# Access Compliance Report

## Public Rights-of-Way

Intersection ID: 47301	Main Street: WOODRUFF_PL	Cross Street: HURSTON_CR	Location:	N
ADA ID: D6BA16BB896E	Ramp Type: Perp	Initial Pass/Fail: Fail	Overall Compliance: No	Severity Score: 13.75

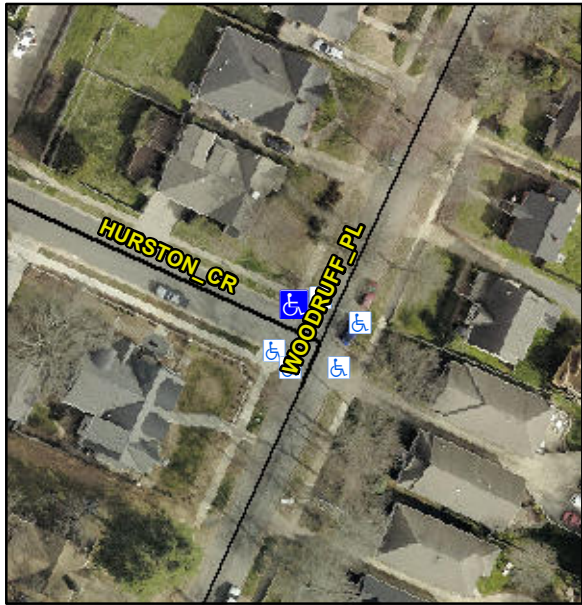
Codes/Mitigation Info/Possible Solution			Field Measurements/Component Compliance					
	Possible Solutions:		Compliance	Description	Data	Compliance	Description	Data
	Remove & Replace Entire Ramp.		N/A	Ramp Length (in)	46.5	No	Ramp Slope (%)	11.7
			Yes	Ramp Width (in)	53.0	No	Ramp XSlope (%)	3.3
			N/A	Flare Type LT	N/A	N/A	Flare Type RT	N/A
			N/A	Flare Slope LT (%)	N/A	N/A	Flare Slope RT (%)	N/A
			N/A	Flare Traversable LT?	N/A	N/A	Flare Traversable RT?	N/A
			N/A	Landing Length (in)	N/A	N/A	DWS Provided?	N/A
			N/A	Landing Width (in)	N/A	N/A	DWS Contrast?	N/A
			N/A	Landing Slope (%)	N/A	N/A	DWS Length (in)	N/A
			N/A	Landing X Slope (%)	N/A	N/A	DWS Full Width?	N/A
Surveyor Notes:		N/A	N/A	Landing Curb? (Y/N)	N/A	N/A	DWS Offset (in)	N/A
PROW/ADA:		Not Found, R304.2.2, R304.5.3	N/A	Shared Landing?	N/A			
			N/A	Gutter Ponding?	Yes	N/A	Gutter Slope (%)	N/A
			N/A	Gutter Lip Ht (in)	N/A	N/A	Gutter X Slope (%)	N/A

N/A	Painted X Walk1?	No	N/A	Painted X Walk2?	N/A
				X Walk 1 Direction	To SW		X Walk 2 Direction	N/A
			N/A	X Walk 1 Width (in)	N/A	N/A	X Walk 2 Width (in)	N/A
				X Walk 1 Slope (%)	3.1		X Walk 2 Slope (%)	N/A
				X Walk 1 X Slope (%)	1.2		X Walk 2 X Slope (%)	N/A
			N/A	Ramp inside XWalk1?	N/A	N/A	Ramp inside XWalk2?	N/A
				Road Slope (%)	N/A	N/A	Clear Space?	N/A
				Road X Slope (%)	N/A	N/A	Clear Space to XWalk (in)	N/A
			N/A	Any Obstructions?	N/A	N/A	Storm Grate/Utility Hazard?	N/A
				Obstruction Type			Storm Grate/Utility Type	
						N/A		N/A
						Yes	Surface Condition? (G/P)	Good
Total Cost:		\$ 1850.00
